Subject: Millennium Tower  
301 Mission Street, San Francisco  
Two Differing Plans for Foundation Retrofitting

This correspondence briefly discusses two foundation plans (external asymmetrical and internal symmetrical) engineered separately for retrofitting support to the subsided and tilted Millennium Tower. This report is provided as a public service as one of the plans seriously affects the City.

EXTERNAL ASYMMETRICAL FOUNDATION PLAN

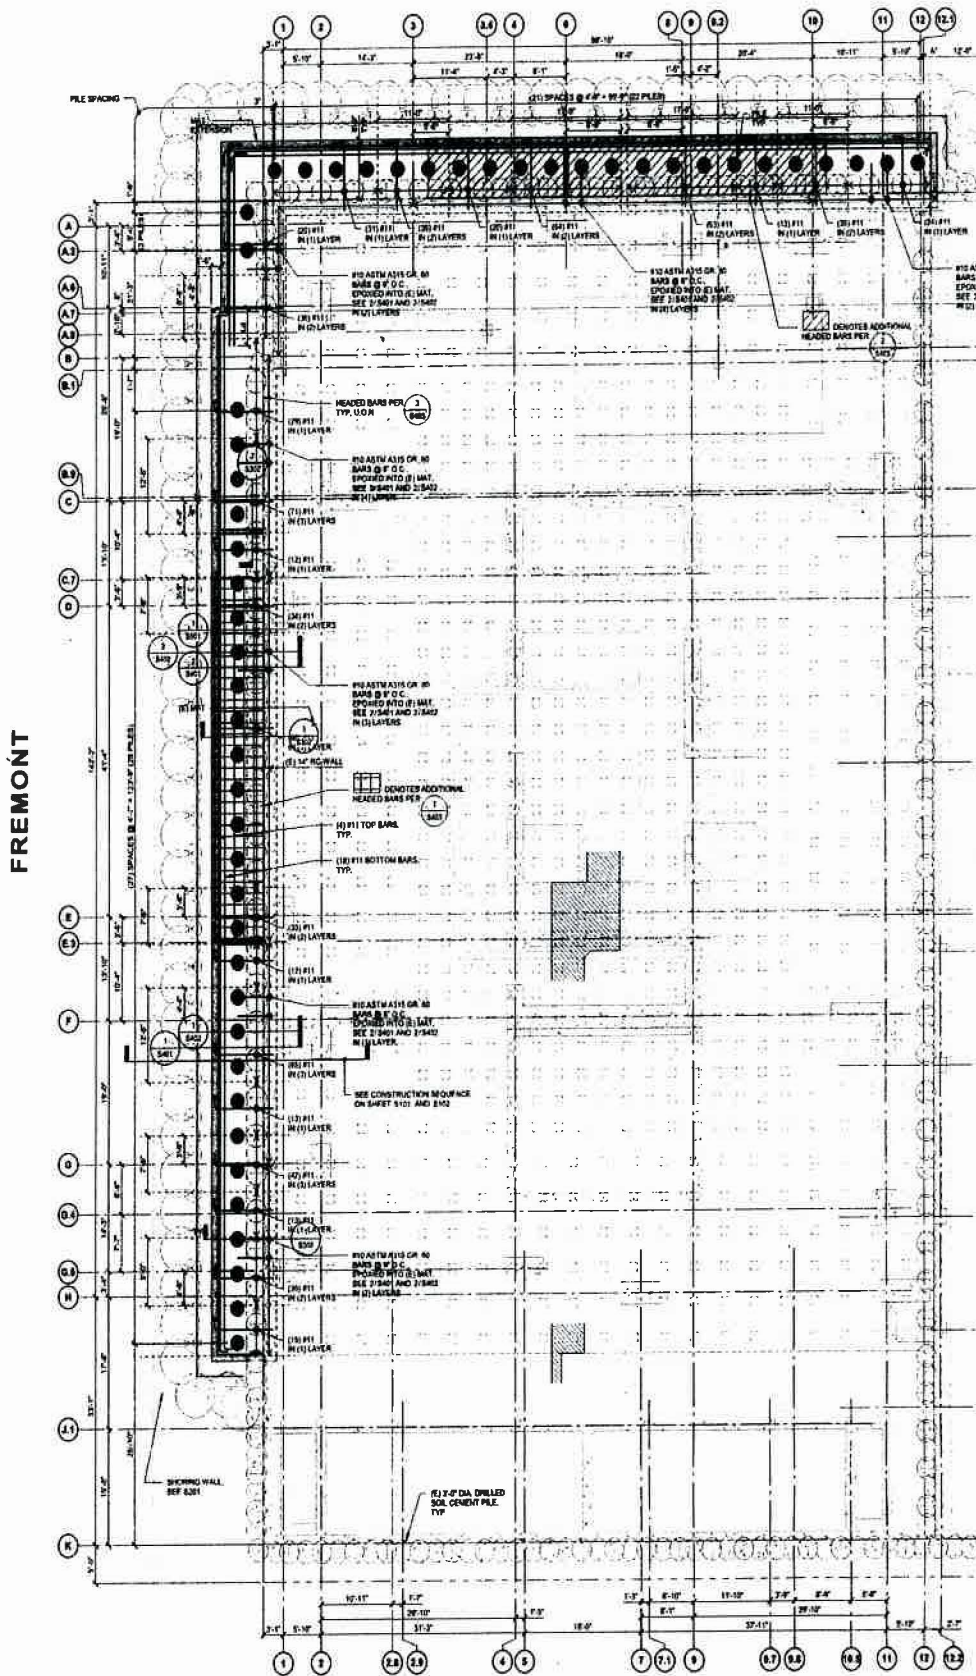
The external plan (attached schematic), designed by Simpson Gumpertz & Heger (SGH) Consulting Engineers has a total of 52 drilled and cased very closely spaced piles along Mission and Fremont Streets; 30 along Fremont and 22 along Mission that are connected by a continuous concrete pile cap that will be doweled into the existing substructure so the new piles will provide bedrock support, which will be eccentric, for about one-fifth of the building's total load.

An SPTC wall 47 feet deep will be built to shore a 27 foot deep, 10 foot wide excavations in both streets between the shoring and the existing substructure. A 5 foot thick grout plug will be constructed at the bottom of the excavation to prop the shoring at excavation subgrade, restrict backslope subsidence and basal heave, and provide an area to work in the dry. Piles will be drilled from the street and cased from bedrock to the level of the mat's bottom.

The major initial problem with construction of the external plan that has no realistic practical or theoretical solution is further loss of groundwater, which is likely to cause more irreparable damage to the building's substructure regardless of subsequent attempts to counter the effect of supporting the existing mat with flat jacks on the piles. Drilling, casing, and removal of spoils from the site to construct closely spaced 52 piles, 36 inch diameter holes to the top of the Old Bay Mud (80 feet below street grade) to become 24 inch diameter piles more than 200 feet deep will cause loss of ground which comes with loss of groundwater that will worsen the problem from dewatering that created the condition in the first place in the area of the planned new piles.

Exacerbating the loss of groundwater with removal from Fremont and Mission Streets of about 1,500 CY of soil and water from the combined locations of the piles will be dewatering necessary to excavate the planned 10 foot wide 27 foot deep trench, 125 feet along Mission Street and 175 feet along Fremont Street, about 3,000 CY. Present groundwater levels near the intersection of Fremont and Mission Streets are at about 23 feet from street grade. With construction of the grout plug in Young Bay Mud, the trench will require groundwater levels along Fremont and Mission Streets to be drawn down to at least 33 feet from street grade, or about 10 feet down from the present GWT.

Groundwater withdrawal without recharge lowers the groundwater table which with building loads increases overburden pressure on compressible soils. Lowering the GWT another 10 feet for the design and to create workable space in the Young Bay Mud for the grout plug will cause the building to further settle differentially with associated damages to the building's substructure. From geometry, for every new inch of differential settlement of the Millennium Tower at Fremont and Mission Streets, the top of Millennium Tower will lean about an additional 4 inches. The tilt will be unacceptable to the owners of the residences and the public. Severe increased breaking and cracking of the concrete base and rotation/failure of the pile heads due to more differential settlement will cause further irreparable damage.

The asymmetrical external foundation plan, consisting of perimeter piles along two adjacent sides of the building, will create a major horizontal structural irregularity. This will be a torsional irregularity as the new piles are relatively strong load-resisting elements but there are no comparables on the opposite sides of the building. Earthquakes have repeatedly shown that buildings that have irregular configurations suffer greater damage; for irregular plans, torsion is caused by eccentricity between the centers of mass and rigidity. In regular structures inelastic response with energy dissipation and damage produced by strong ground shaking will be distributed throughout the building. For the external foundation plan, where a seismic event will generate base shears that are derivatives of the building's weight in precisely the direction of the new pile rows which may passively resist them, forces in other directions will cause torsion to other building elements or will not be resisted by available passive, such as along Minna Street. In such irregular structures, inelastic behavior may be concentrated. The existing 14 inch square (with chamfered corners) piles, even with tops reinforced likely have rotated heads, crushed portions of concrete, and bent bars as a result of the differential settlement of the mat foundation that was meant to tie the piles together for group action. Narrow concrete piles that are prefabricated with prestressing strands are for the purpose of resisting breakage during lifting, and with cushions to resist driving forces; their heads are not meant to rotate. Ground motions acting on a skew with respect to the building's axis can cause torsion. 2016 California Existing Building Code §403.9.4, for voluntary seismic improvements, requires that alterations do not create a structural irregularity.

If the project is approved by the City, there seem to be questions about easement or ownership of the land that the City may grant to the Millennium Tower Association. The tiebacks for the SPTC wall will have to remain in the street area, as have the tiebacks for 301 and 350 Mission. The SPTC shoring wall, building extension, piles, and vaults will be permanent.

For the excavation into San Francisco public streets to enlarge the footprint of the Millennium Tower, 10 feet wide between the shoring wall and 300 feet long (125 feet along Mission and 175 feet along Fremont), there will have to be rerouting of underground utilities, fencing, staging area for materials, operating of excavation and drilling equipment, trucking of spoils including contaminated materials from dumping and other fills over the 1852 shoreline, which will tie up portions of two way Mission and one way Fremont up for a year or more. The Fremont off ramp from the Bay Bridge is the major entrance to downtown every weekday morning, the option of turning on Howard is awkward because of one way streets so the blocking at Fremont and Mission will be very disruptive and will have serious effects on downtown traffic. The cost of municipal vehicles, equipment, and personnel to control traffic will have to be borne by the City.

INTERNAL SYMMETRICAL FOUNDATION PLAN

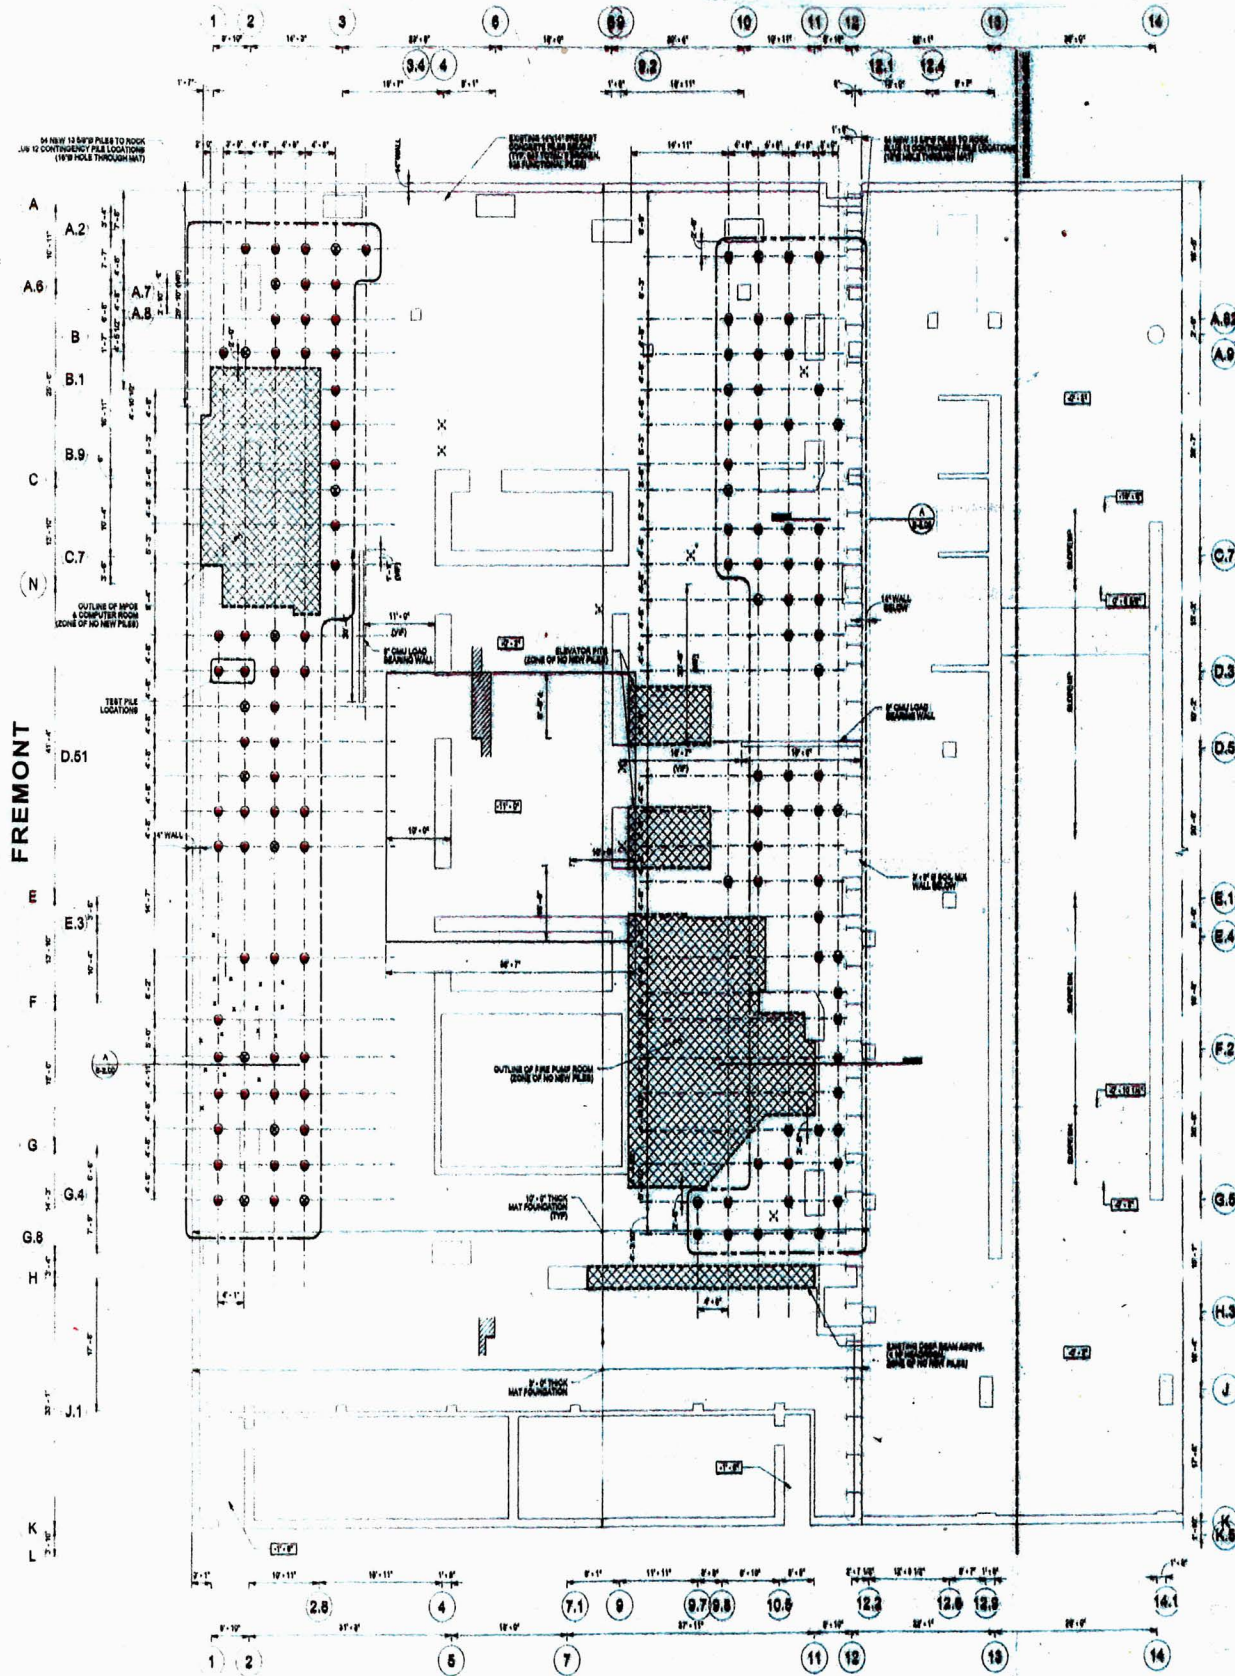
The internal plan (attached schematic), designed by Leslie E. Robertson Associates (LERA), Consulting Structural Engineers, designer of the World Trade Center in New York, has a total of 108 new steel jacketed piles, 54 on the Fremont side and 54 on the opposite side of the building, arranged in a symmetrical longitudinal and transverse pattern that are installed inside the basement and will perform entirely within the building's footprint. The upper portions of the 13-5/8 inch outside diameter 5/8 inch wall thickness steel rock piles are 30 feet long in and below the existing concrete mat, and inside the larger pipes are 9-5/8 inch outside diameter 1-3/8 inch wall thickness steel rock piles. The smaller piles extend through the larger piles into bedrock that is projected to be 220 feet from the bottom of the Millennium Tower mat portion of the substructure.

The entirely new pile system will provide full uniform and symmetrical vertical and lateral support for the Tower. The new lateral resistance to base shear provided by the 108 13-5/8 inch diameter piles below the mat is a much improved lateral force resisting system over the original design that relied on passive resistance against the basement wall and the prestressed concrete piles with the design assumption that the bottom of the mat substructure would remain level.

The new piles will be jacked into bedrock through holes cut through the basement slab. The jacking system uses the weight of the concrete building as a reaction. Pile locations as finally set were arranged to avoid MPE utilities, computer facilities, and fire pump house. Pile sections have threaded connections, there is no welding and annular space in the piles are grouted. The internal plan does not involve any dewatering and there is no drilling through soils. There is potential with the internal plan to at least partially return the substructure to a more level condition during the jacking process.

The internal symmetrical plan arrests movement and restores value to the owners and the public using a completely new foundation system. Full lateral support will be provided with the internal plan, where the external plan depends in part on failed (or about to fail) now low capacity piles where adjustable input computer studies about rotated pile heads show perhaps the first major seismic event may be resisted, but with unknown residual capacities for aftershocks or subsequent earthquakes. Last week the southern part of the State had an M=6.4 event which was followed the next day by an M=7.1 event. Dewatering for the basements of buildings along Mission Street will continue as will groundwater flow under Mission Street to the Bay, but recharging if any will not continue during drought periods. The only real solution that will benefit the owners and the public in the years to come, without constant monitoring and more awful publicity for the City and engineers, is the pile support replacement using an internal symmetrical foundation plan.
